2.0 SITE CHARACTERISTICS

2.0.2 Summary of Application

Figure 2.5.2-6. Mean Hazard Curves for the NMSZ (New Madrid) and Charleston Sources of Repeated Large-magnitude Earthquakes (RAI 02.05.02-18 Figure 1)

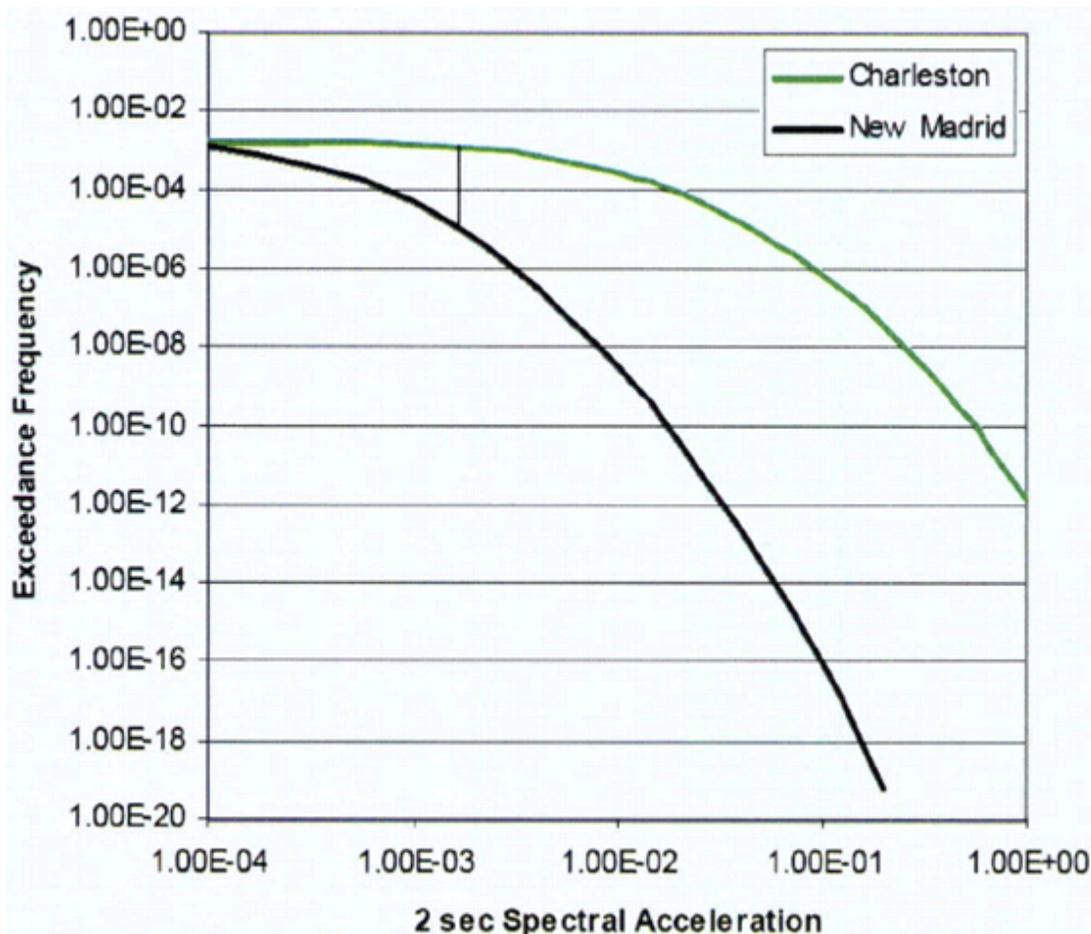
In response to RAI 2.5.2-18, the applicant provided the staff with its evaluation results of the effect of NMSZ to the hazard at the LNP. SER Figure 2.5.2-6 compares the 2-second mean spectral acceleration hazard of repeated large-magnitude earthquakes for the NMSZ to that computed for earthquakes in the region of Charleston, South Carolina. The Charleston source was included in the LNP PSHA. SER Figure 2.5.2-6 illustrates that the mean hazard from the NMSZ is less than 1 percent of the hazard from the Charleston source for the 2-second spectral acceleration. The NMSZ is a distant source zone (> 1000 km (> 620 mi)) from the LNP Units 1 and 2 site. The effect of a large-magnitude earthquake on the site at such distances would be greatest at low frequencies, for example at 0.5 Hz equivalent to the 2-second period used by the applicant in SER Figure 2.5.2-6. Since the hazard of the NMSZ at the LNP Units 1 and 2 site is less than 1 percent of the Charleston source at low frequencies, the NMSZ contribution to the total hazard at the LNP Units 1 and 2 site will be less than that shown in SER Figure 2.5.2-6. Therefore, the NMSZ is not a significant contributor to the seismic hazard at the LNP Units 1 and 2 site. Based on the results of the applicant's testing of the NMSZ, the staff concludes that the NMSZ does not contribute significantly to the hazard at the LNP Units 1 and 2 site and, therefore, does not need to be included in the LNP PSHA. The staff considers RAI 2.5.2-18 resolved.

Figure 2.5.2-8. Increase in Aleatory Variability for Periods Longer than 2.0 Seconds Based on the PEER-NGA Ground Motions (RAI 02.05.02-08 Figure 1)

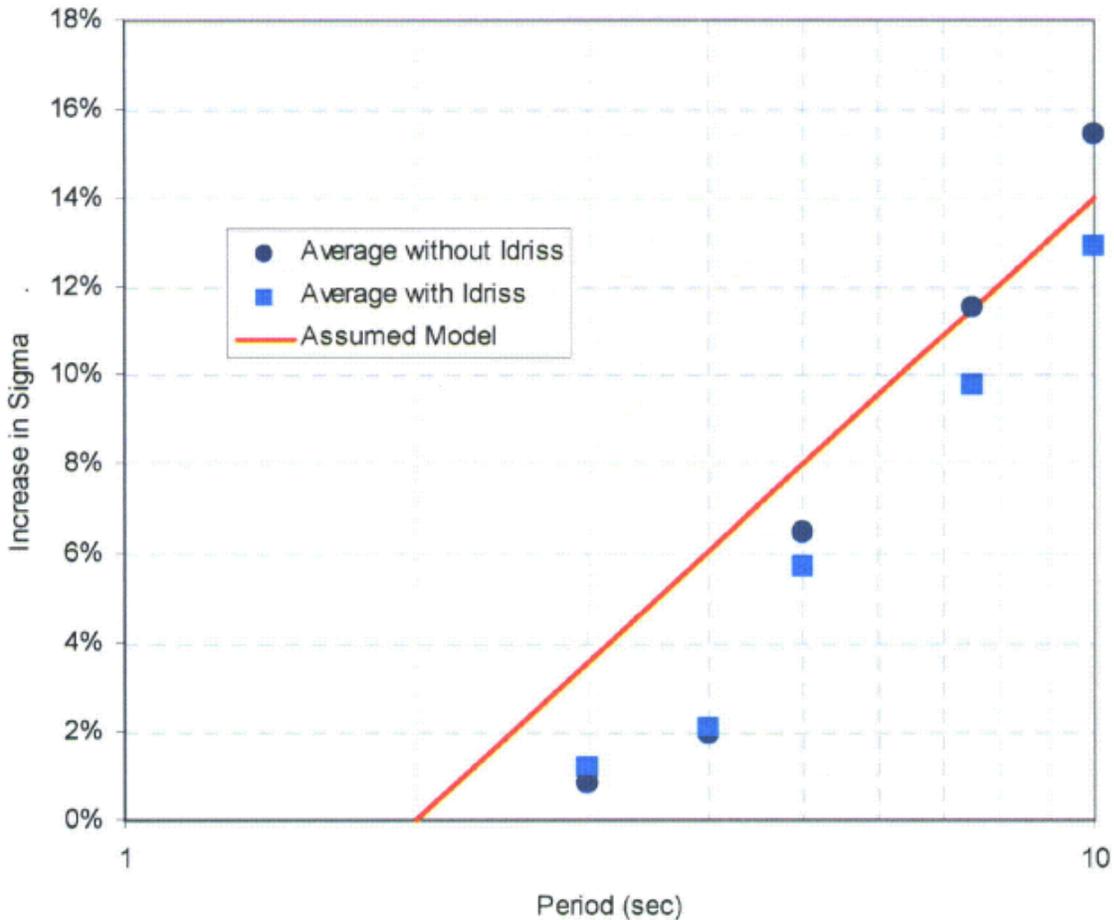
spectral frequencies between 0.1 and 100 Hz, the applicant used a combination of relationships from a number of references. In RAI 2.5.2-8, the staff asked the applicant to identify the sources of relations it used and to illustrate the dependence between the aleatory variability and frequencies that the applicant adopted. In its response, the applicant provided the justification of relations used as illustrated in SER Figure 2.5.2-8. The figure illustrates the relationship between aleatory variability (increase in Sigma) and frequency (or Period). The applicant provided the requested information; therefore, the staff considers RAI 2.5.2-8 resolved.

Figure 2.5.2-9. Pre- and Post-grouting Compressional (V_p) and Shear Wave (V_s) Velocities Suspension Logging Measurements (RAI Figure 02.05.02-1-01)

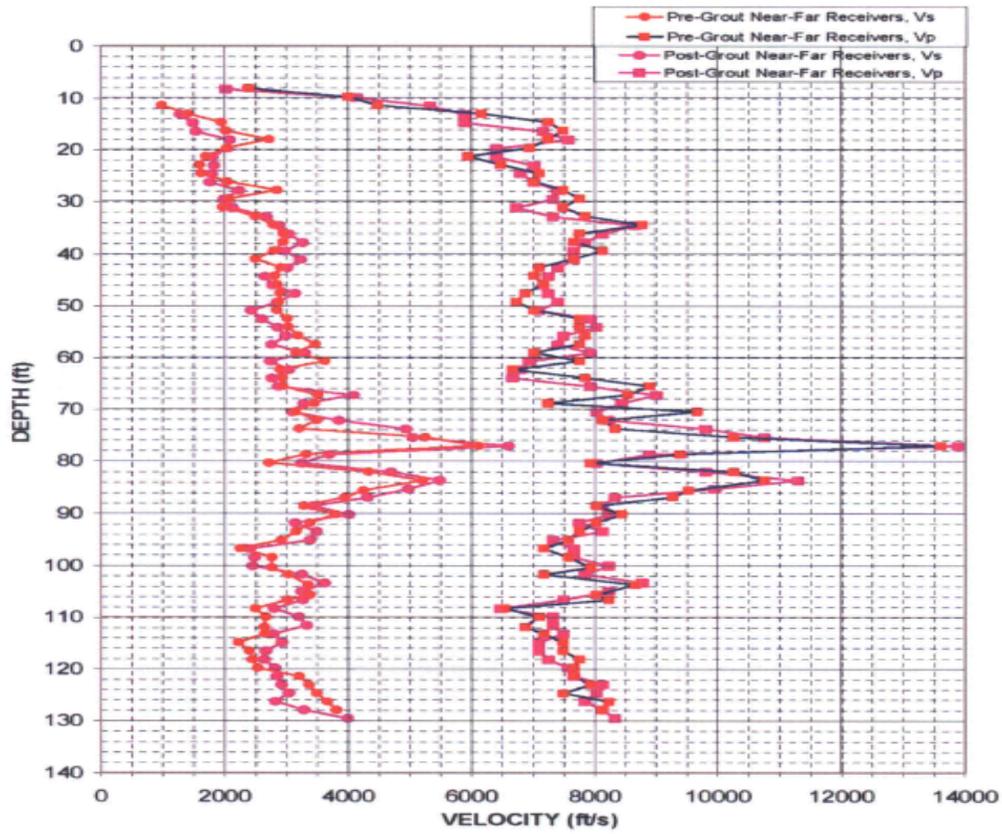
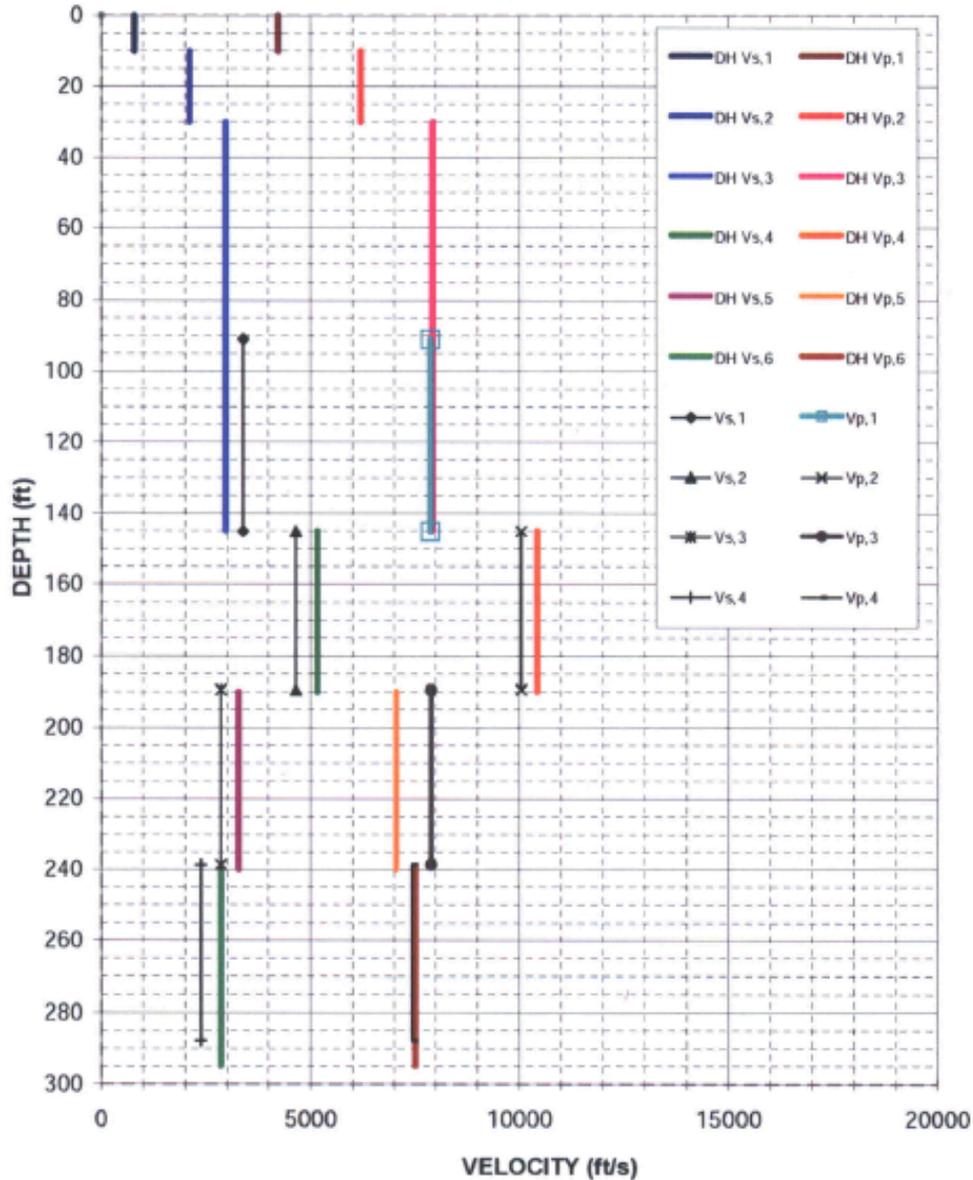
To address the staff's concerns, the applicant conducted a grout test program. The purpose of the grout test program was to validate the applicant's permeation grout program design and grouting techniques, to measure the change in V_S and permeability of the grouted zone, and to determine the amount of grout take in the subsurface. The applicant presented the shear wave test results from its grout test program. During the grout test program, the applicant made pre- and post-grouting measurements of V_S using P-S suspension logging. SER Figure 2.5.2-9 shows the applicant's seismic wave velocity results for pre- and post-grouting measurements. The pre- and post-grouting measurements were performed in cased 10-cm (4-inches (in)) borehole PVC pipe. The applicant additionally addressed a concern of the staff regarding this P-S suspension logging methodology. The staff's concern was whether the casing surrounding the borehole piping affected the applicant's velocity measurements. In response, the applicant provided a figure, which is now SER Figure 2.5.2-10, that illustrates a comparison between velocities obtained using the cased 10-cm (4-in) borehole PVC pipe P-S suspension logging methodology and the downhole layered model methodology.

Regarding the pre- and post-grouting seismic wave velocities, the staff concludes that after the permeation grouting program is concluded, the LNP Units 1 and 2 site will maintain its site uniformity and V_s characterization as described in the LNP Units 1 and 2 COL application. As shown in SER Figure 2.5.2-9, the pre- and post-grouting measurements are within the expected precision of the P-S suspension logging method, and the change in V_s from pre- to

post-grouting is within the standard deviation for the upper layers of the Avon Park Formation. Additionally, SER Figure 2.5.2-10 shows that both the cased and uncased P-S suspension logging methods produce similar seismic velocities versus depth and the comparison illustrates that the casing used in the borehole measurements did not systematically affect seismic wave velocity measurements during P-S suspension logging data collection. These comparative results of the cased P-S suspension logging and downhole layered models, assure the staff that the cased borehole piping did not significantly affect the applicant's seismic wave measurements. The staff considers RAIs 2.5.2-1 resolved.

Figure 2.5.2-11. An Example of the Applicant’s Scaling of Input Acceleration Time Histories Using the Parkfield Earthquake, San Luis Obispo 234° Component to Match the 10^{-4} , HF, DEM Earthquake Target Spectrum (RAI 02.05.02-12 Figure 2)

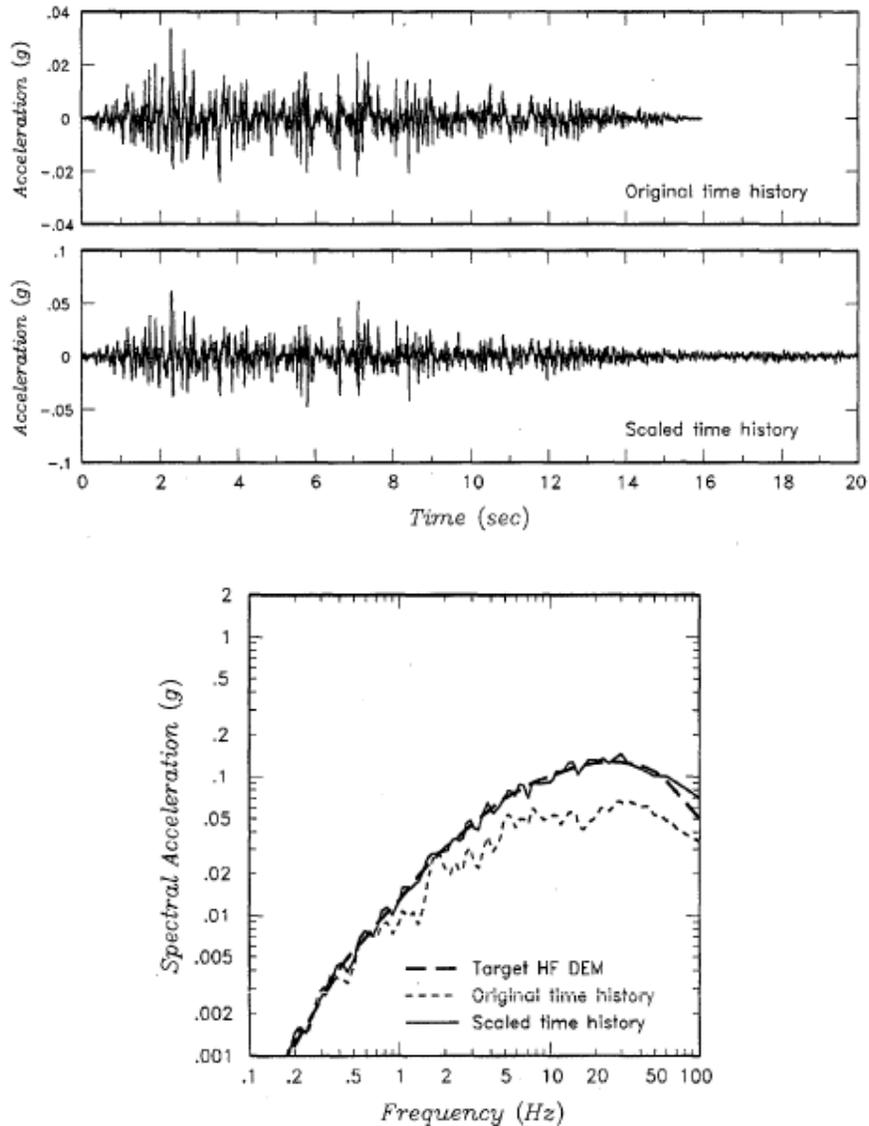
In response to RAI 2.5.2-12, the applicant provided a list of the specific recordings used and recording parameters such as date, time, magnitude, station, and distance from event to station, among others. The applicant chose recordings from active tectonic regions and modified the spectra to have the general characteristics expected for rock site motions in the CEUS. Regarding the scaling of the input response spectra, the applicant explained that it first defined a target spectrum for each controlling and deaggregation earthquake. Second, the applicant scaled the individual input acceleration time histories in the frequency domain to match the target spectra. SER Figure 2.5.2-11 shows the time history from NUREG/CR-6728 and its response spectrum, the target spectrum, and the scaled time history and its response spectrum. After reviewing the specific list of the acceleration time histories used as input motions the staff concludes that the applicant demonstrated appropriate use of the input acceleration time histories and of the scaling process, because the applicant used inputs and scaling consistent with the controlling and deaggregation earthquakes. The staff finds the applicant's response to RAI 2.5.2-12 adequate and considers this RAI 2.5.2-12 resolved.

Figure 2.5.4-8. Typical GSI Factors for Limestone
(Modified from Marinos and Hoek, 2000)

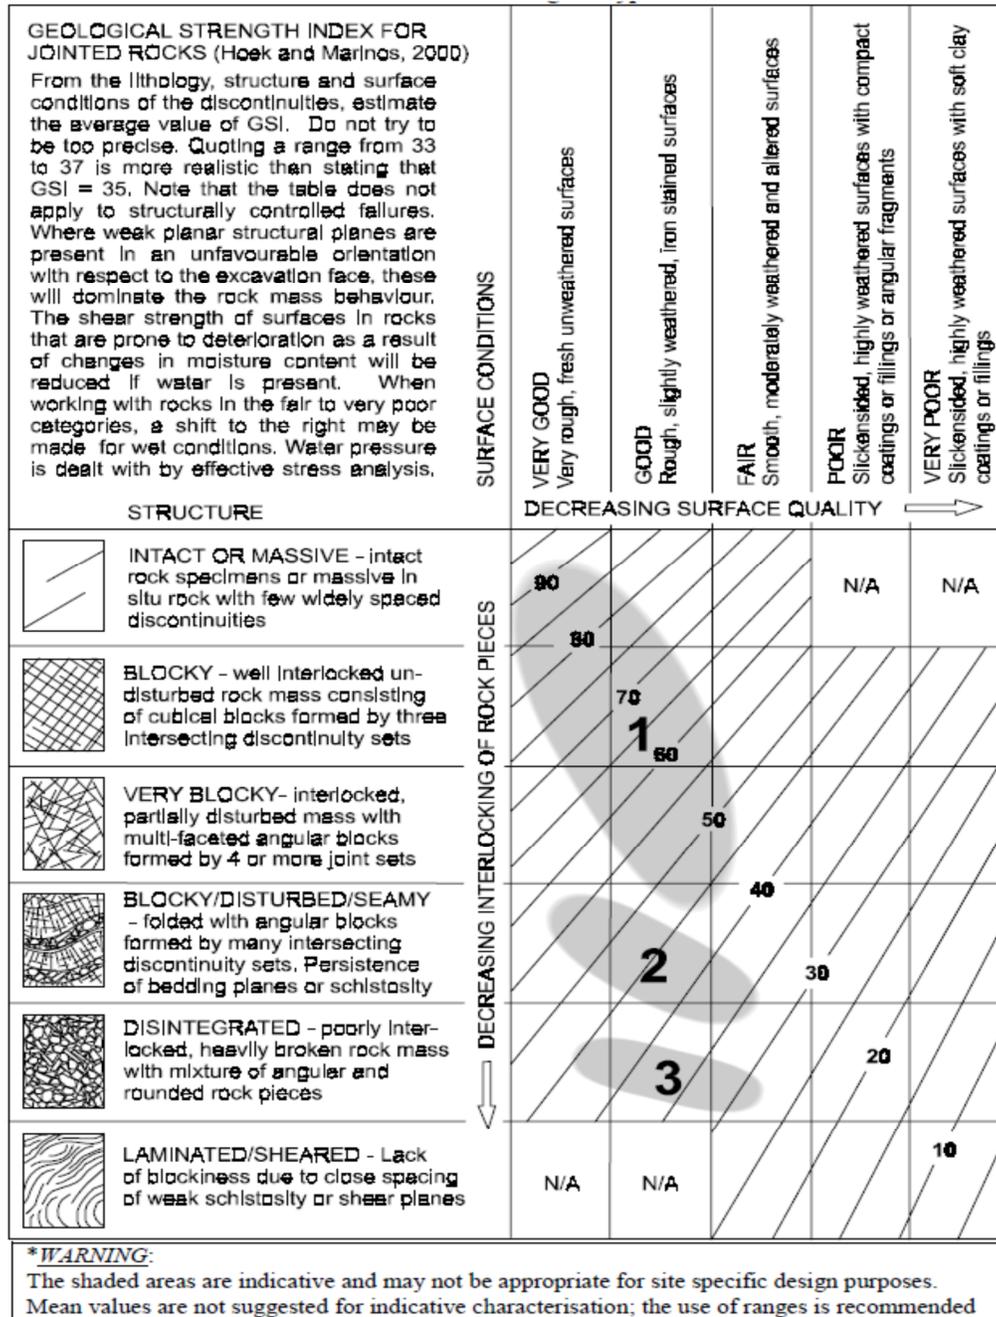
In SER Figure 2.5.4-8, Marinos and Hoek (2000) show the typical limestone GSI values in the shaded zones labeled 1, 2 and 3, which range from 28 to 75 for disintegrated to blocky limestone, with fair to good discontinuity surface quality. The staff noted that most of the Avon Park Formation at the LNP site would fall in this range, with the exception of the severely weathered Avon Park limestone recovered at bedding planes and eroded vertical joints. The staff then overlaid the applicant's estimated GSI range on this figure, shown as labeled, and observed that the applicant's estimated GSI range of 21 to 38 corresponds to a disintegrated to blocky limestone with discontinuity surface quality that would be described as good to very poor. Based on this information as well as its review of the borings and other field data, the staff concludes that this is a conservative representation of the Avon Park limestone. The staff also compared these values with typical limestone GSI values, shaded areas 1, 2 and 3 on SER Figure 2.5.4-8, and concludes that the applicant's estimations of GSI values are conservative. Thus, the staff concludes that the applicant's estimated GSI values adequately represent the observed structure of the Avon Park limestone. Accordingly, RAI 2.5.4-7a is resolved.

Figure 2.5.4-12. V_s Profiles in Boring AD-03 and Boring AD-20
(Excerpted from FSAR Figure 2.5.4.2-204B)

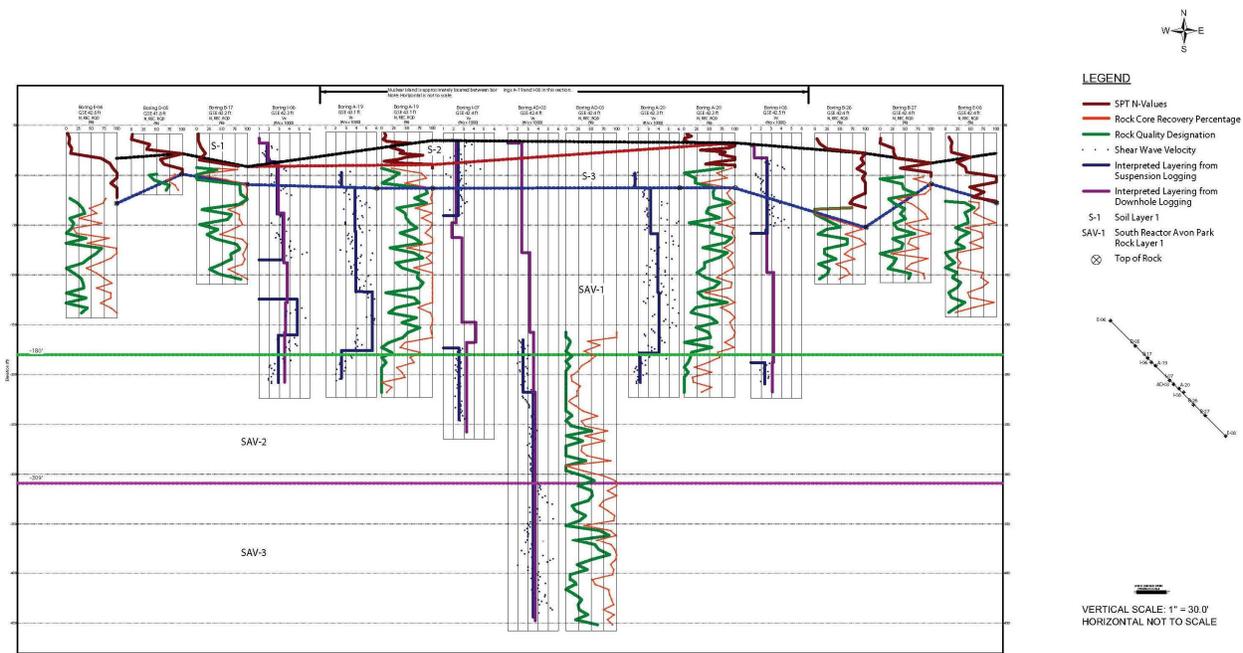
Figure 2.5.4-12 shows the V_s measured in borings along the N-S profile at LNP Unit 1. The blue dots represent individual V_s measurements and the blue line is the average of those measurements. Adjacent to the V_s profiles are plotted the sample recovery percentages and the RQDs determined during drilling that correspond to the V_s profiles. The lighter red line in this figure represents the sample recovery and the solid green line the RQD. The staff observed no consistent correlation between low recovery and V_s . From this figure, it is apparent to the staff that even at very low recovery rates, the V_s is typically greater than 457 m/s (1,500 fps). From the V_s data the staff concludes that the low recovery zones do not represent voids or soil-filled voids, which was later confirmed by the offset boring program. The staff, therefore, concludes that the maximum size of a void of 3 m (10 ft) diameter is conservative. Accordingly, RAI 2.5.4-6 is resolved.

Figure 2.5.4-13. Effective Cyclic Shear Stress as a Function Of Variable V_s Assumptions in the Engineered Fill (RAI Figure 2.5.4-26-2)

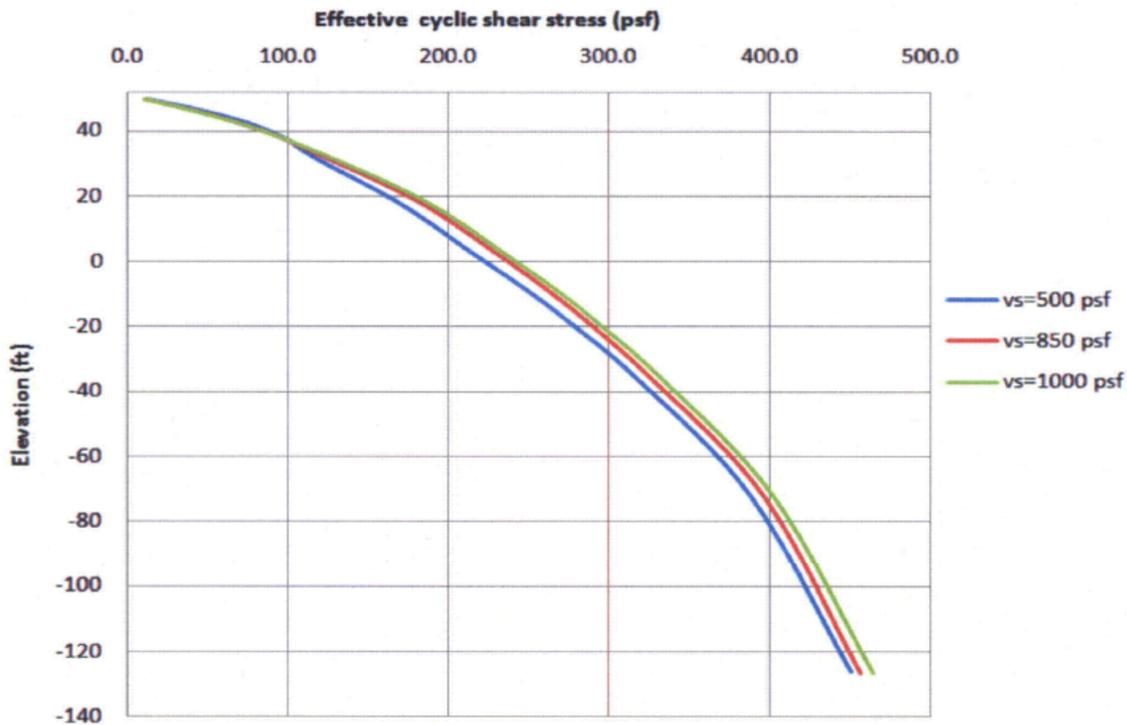
In determining what value to use for the V_s , the applicant performed a dynamic sensitivity analysis, which varied the V_s of the engineered fill by values of 152, 259 and 305 m/s (500, 850 and 1,000 fps). The results of this analysis are provided in SER Figure 2.5.4-13, which compares the computed effective cyclic shear stresses between an El. of 10.9 and -41.1 m (36 and -135 ft) for variable V_s .

Figure 2.5.4-16. Distribution of Postulated Soft/Stiff Regions and Thirteen Soft 0.3-m (1-ft) Thick Bedding Layers (RAI 2.5.4-11 Response Figure 2.5.4-11-02)

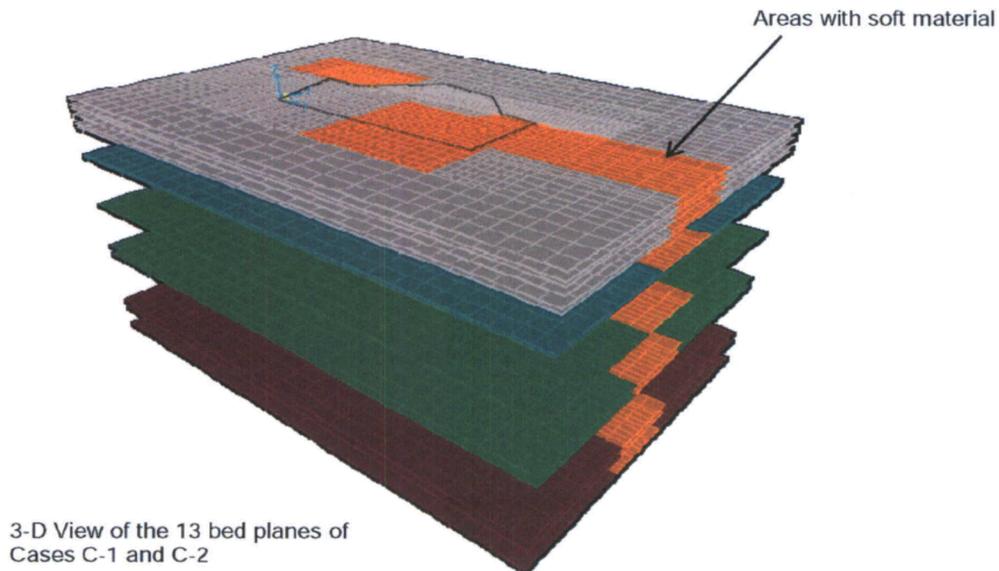
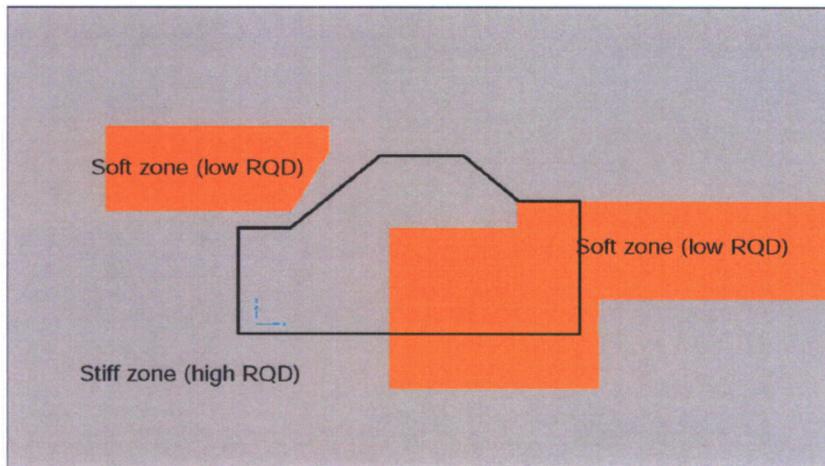
Cases C-1 and C-2
